RE: Response to USEPA Comments (dated 02/26/15) on Focus FS Report – Revision 1 and Submittal of Focused Feasibility Study Report – Revision 2

Waukegan South Plant Manufactured Gas Plant (MGP) facility in Waukegan, Illinois
North Shore Gas Company

CERCLA Docket No. V-W-'07-C-877
CERCLIS ID – ILD984809228

Figure 16 – PRELIMINARY Framework for DNAPL Recovery Performance Standard
Former South Plant Site
North Shore Gas

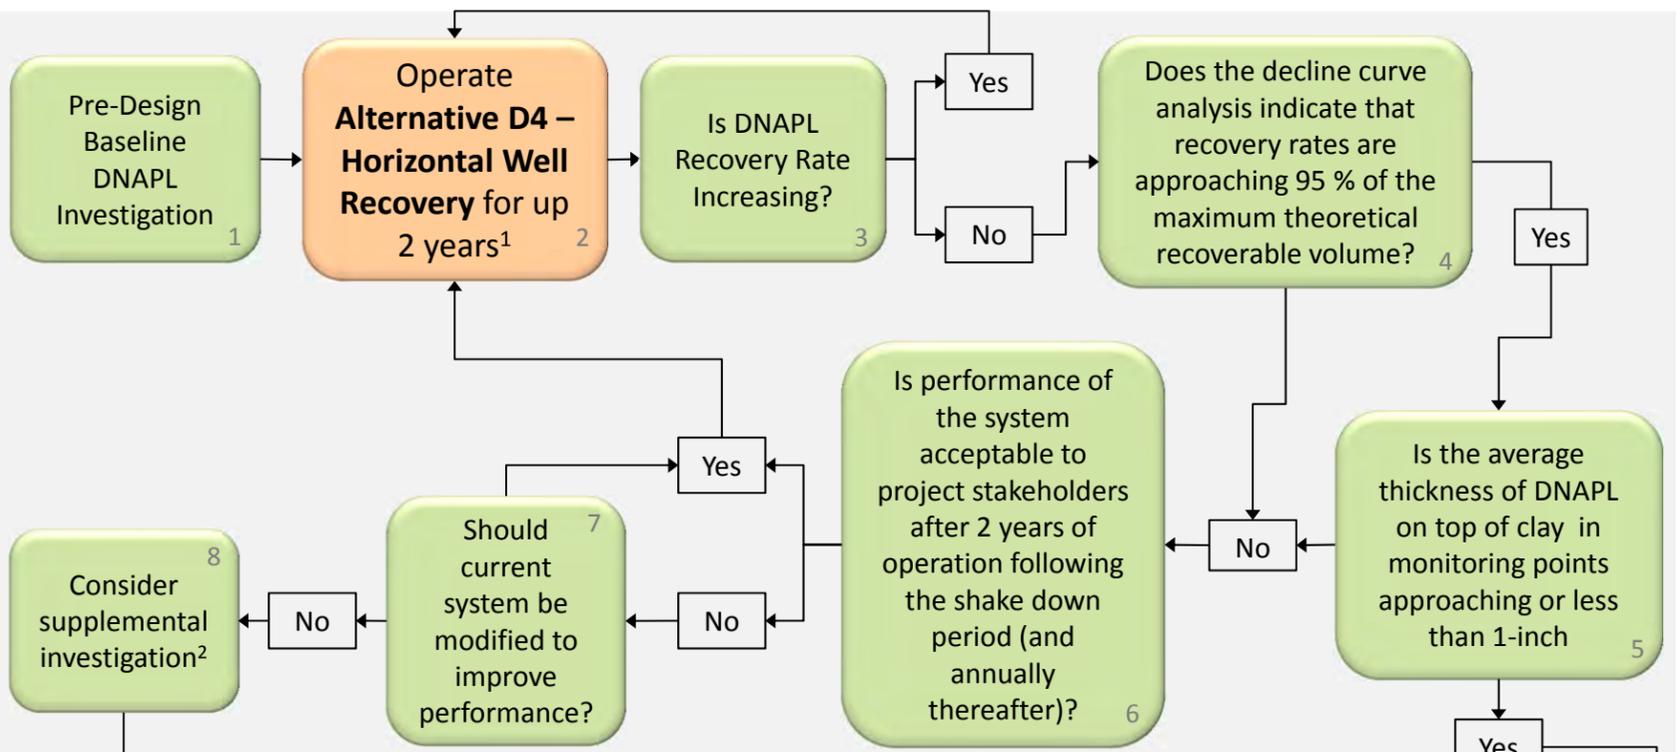
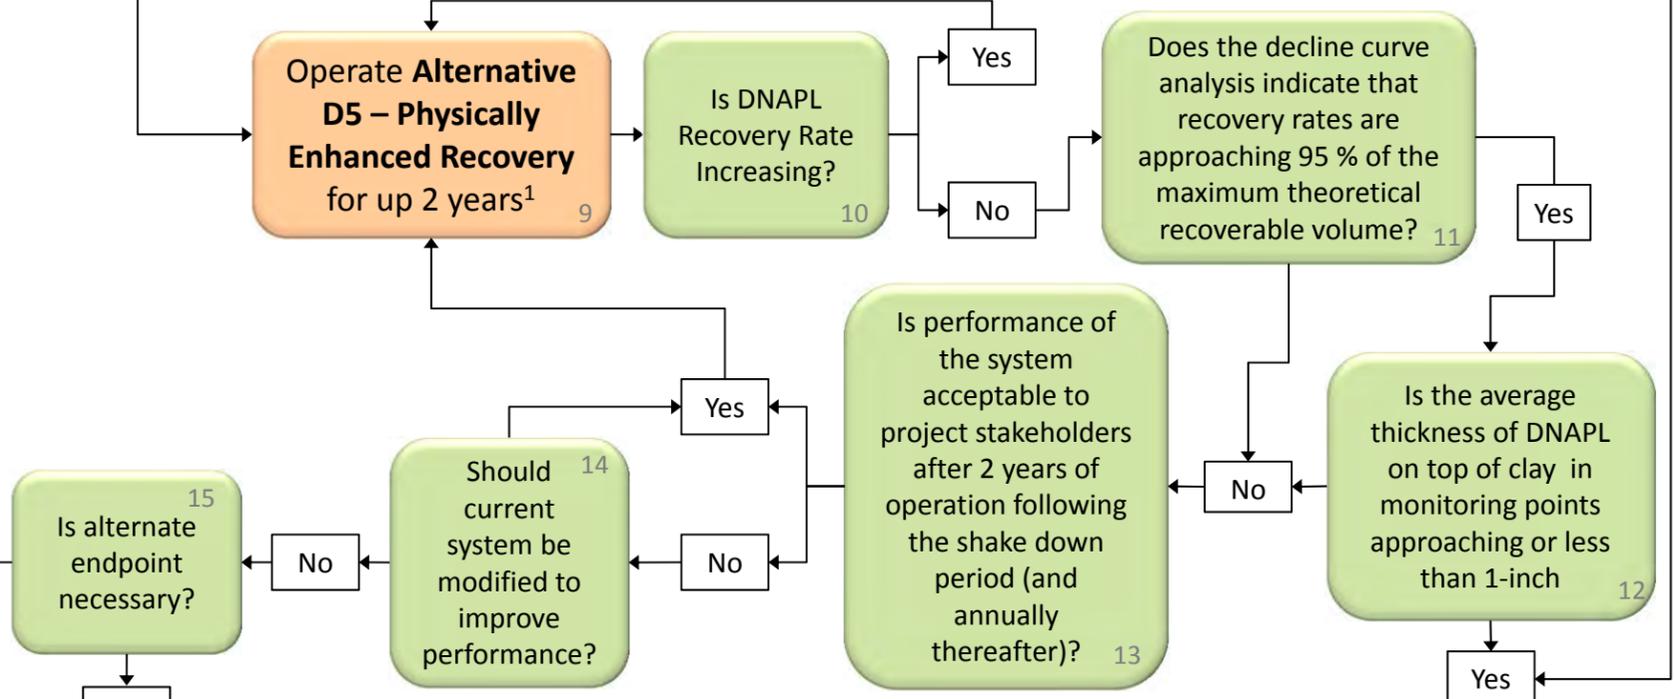
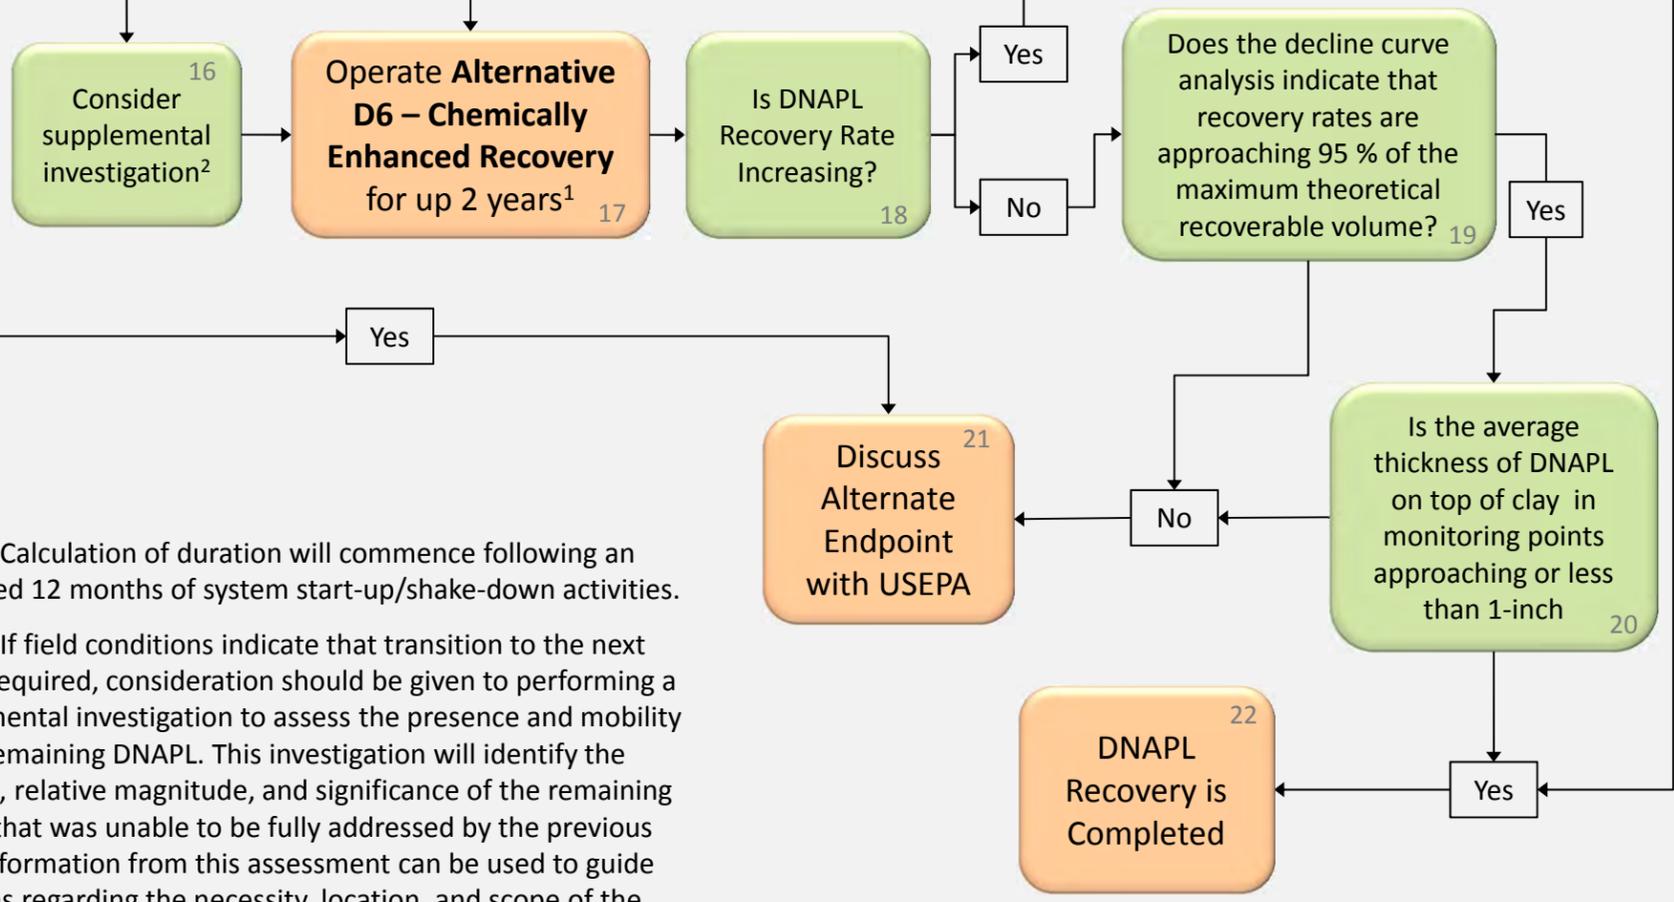
- 5. In Reference to Previous USEPA FFS Specific Comment #1 and IBS's Response:** *As is specified in the revised FFS Section 4.5.2, it is requested that the DNAPL pre-design investigation take place before implementation of Option D4. Figure 16 should be modified accordingly to show the pre-design DNAPL investigation occurring before implementation of option D4, and language in Sections 6.3 and related Section 6.2 should be clarified to reflect the pre-design investigation. Pre-design investigations should be done as soon as possible to provide an updated baseline of DNAPL presence, mobility, thickness, and volume which will assist in not only locating horizontal wells, but also in providing information that will allow better assessment of DNAPL presence across the site. The details of the pre-design investigation can be provided in the planning phase, however, Integrys should plan to integrate analytical approaches to measure pore fluid saturation, interfacial tension, and mobility thresholds in the subsurface that could provide important information for system design. These approaches, if applied before and after remediation phases, could be very useful in demonstrating how the system was performing (along with operational data observations).*

- 6. Figure 16 Additional Comments:** *See attached recommended changes to Figure 16.*

STEP 1. Draft versions of this figure presented on January 8 indicated that field monitoring (i.e., a measureable decrease as illustrated by monitoring) would serve as the decision metric. However, the revised Figure 16 includes a metric which is undefined and appears insufficient for decision making purposes (See proposed modifications to Figure 16).

STEPS 1-3. The current decision flow did not appear to allow the process to continue to the next step after 2 years (See proposed modifications to Figure 16).

IBS Response: A pre-design investigation box has been added to Figure 16 in advance of Option D4. As discussed with USEPA, the exact details of this investigation will be tailored to the selected remedial option and will be developed in a remedial design work plan. IBS will consider the value of the referenced analytical approaches during the Proposed Remedial Action Plan and Record of Decision Process. As such, no changes have been made in the Focused FS Report.

IBS Response: Figure 16 has been updated based on the discussions during the March 11, 2015 conference call and the modified figure provide by USEPA in an email sent on March 12, 2015.
